North Liberty Planning Commission
Tuesday, September 1, 2020, 6:30 PM

To **City of North Liberty Planning Commission**
From **Ryan Rusnak, AICP**
Date **August 28, 2020**
Re **Request of Cherry Pig LLC to approve a Preliminary Plat for a two lot subdivision at 135 Cherry Street.**

To **City of North Liberty Planning Commission**
From **Ryan Rusnak, AICP**
Date **August 28, 2020**
Re **Request of Casey's Marketing Company to approve a Site Plan on 1.58 acres for the redevelopment of the property located at 600 Westwood Drive and 230 Sugar Creek Lane.**

To **City of North Liberty Planning Commission**
From **Ryan Rusnak, AICP**
Date **August 28, 2020**
Re **Request of the City of North Liberty for an ordinance amending Section 167.01 of the North Liberty Code of Ordinances, entitled “Definitions” and various sections in Chapter 169 of the North Liberty Code of Ordinances, entitled “Development Regulations”.**

PROJECT NAME: CASEY'S NORTH LIBERTY, IA
DRAWING NUMBER: RL-6841-S1-R1

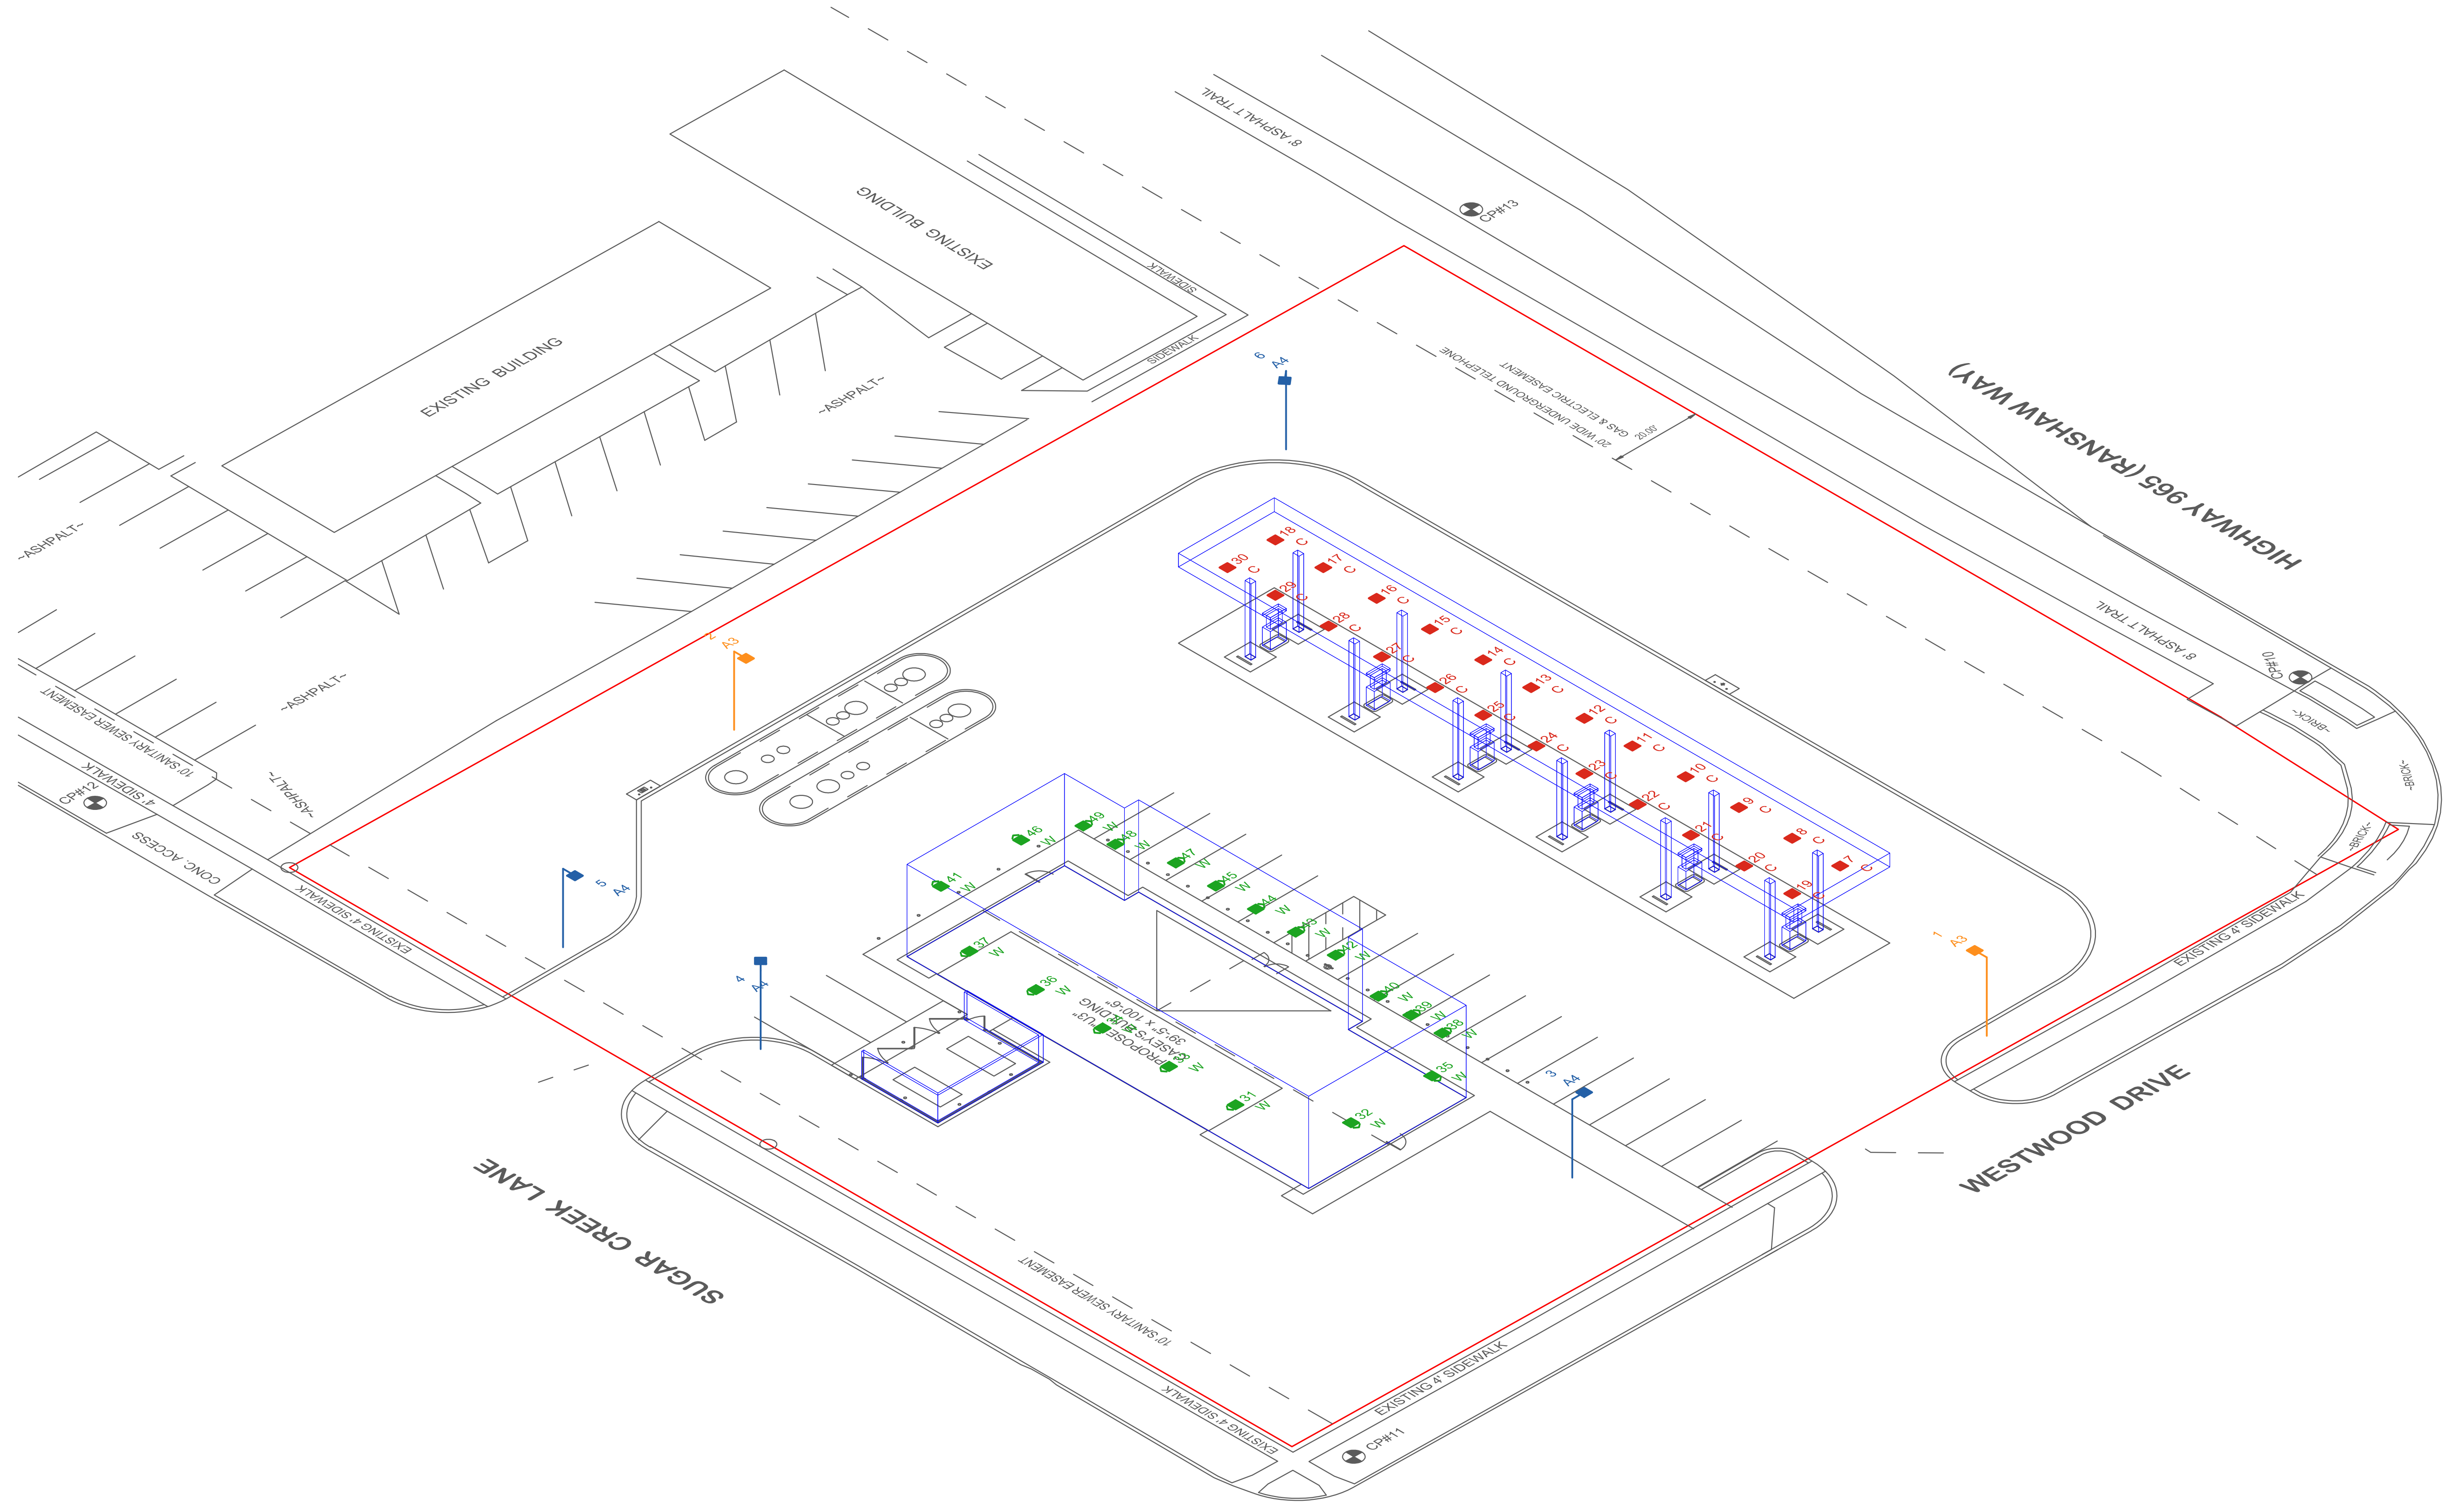
1. That the lighting be adjusted so it does not exceed one footcandle along the west property line, consistent with Section 169.12(1)(5) of the North Liberty Code of Ordinances;
2. That prior to issuance of a certificate of occupancy the applicant dedicate a sidewalk easement to the City for any portion of the public sidewalk that extends onto private property as are shown on the site plan, subject to approval as to form and content by the City Attorney; and
3. That prior to issuance of a certificate of occupancy a plat of survey formally combining the two lots into one lot in accordance with Section 180.10(2) North Liberty Code of Ordinances be recorded with the Johnson County Recorder, and that applicant is responsible for any costs associated therewith.
